## **REMARKS**

### ***Drawing Objections***

FIG. 5. SECTION A-A

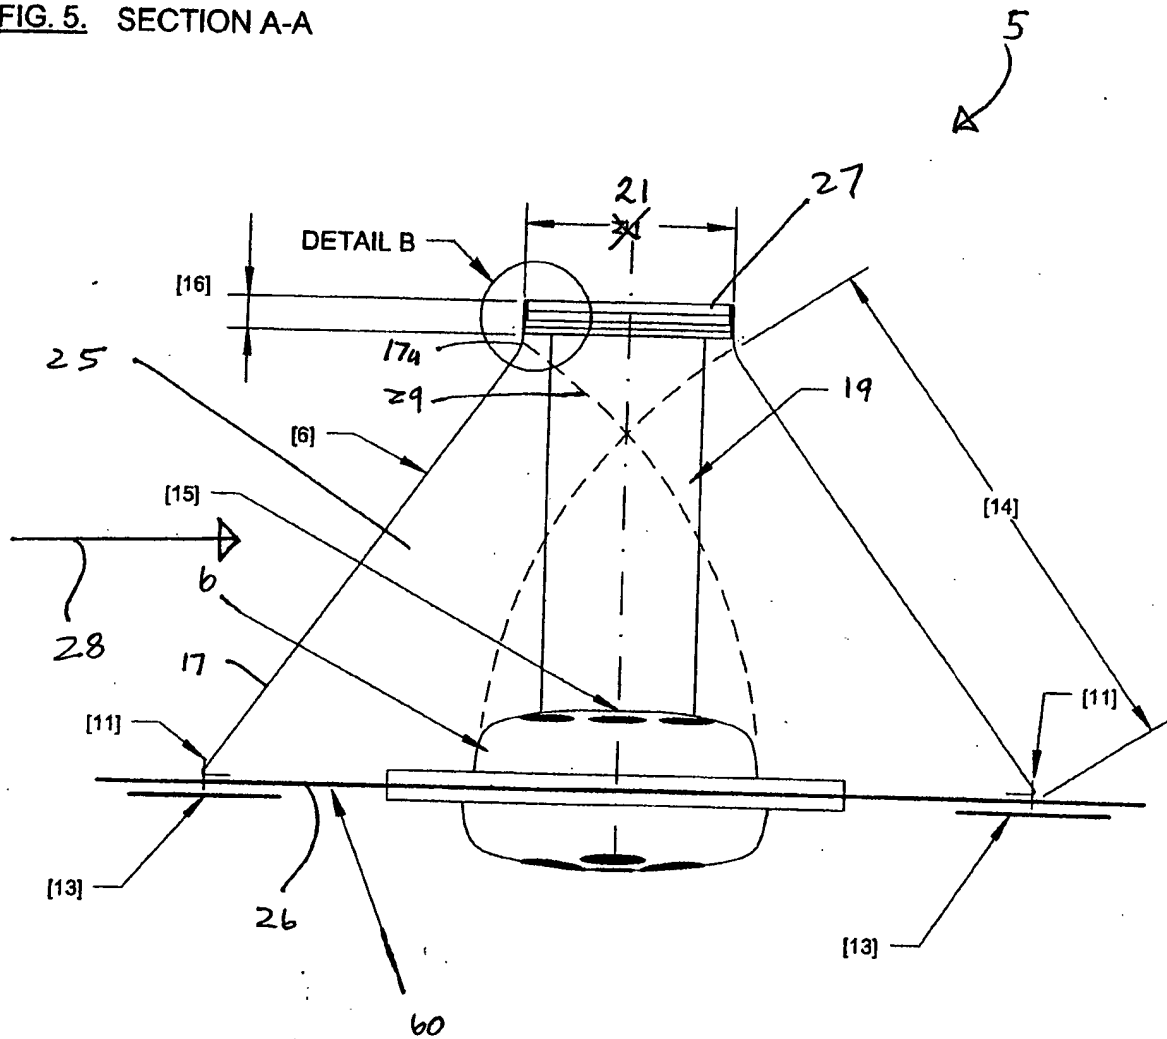
The claims recite that the cover is “deformable,” not “deformed” as thought by the examiner. Figure 5 shows how the cover is deformable by illustrating an exemplary path of deformation shown by broken line 29 (see paragraph [0051]). The recitation of “deformable” in claims 1 and 4 is shown in the drawings.

The tapered shape (claim 7), the frusto-conical shape (claim 8), and the base configuration claimed in claim 18 are all illustrated in Figure 5, which shows a tapered shape that is frusto-conical, and which shows how the base end is secured to the immersion suit at reference numerals [11] and [13]. The circular head end (claim 10) and the circular cross-section (claim 11) are clearly visible in Figure 4.

The reference numeral near the top of Figure 5 should read “21,” as shown more clearly on the attached sheet.

The attached sheet of drawings includes changes to Figure 5. This sheet replaces the original sheet containing Figure 5. In Figure 5, reference numeral 21 near the top of the figure is now clearly shown.
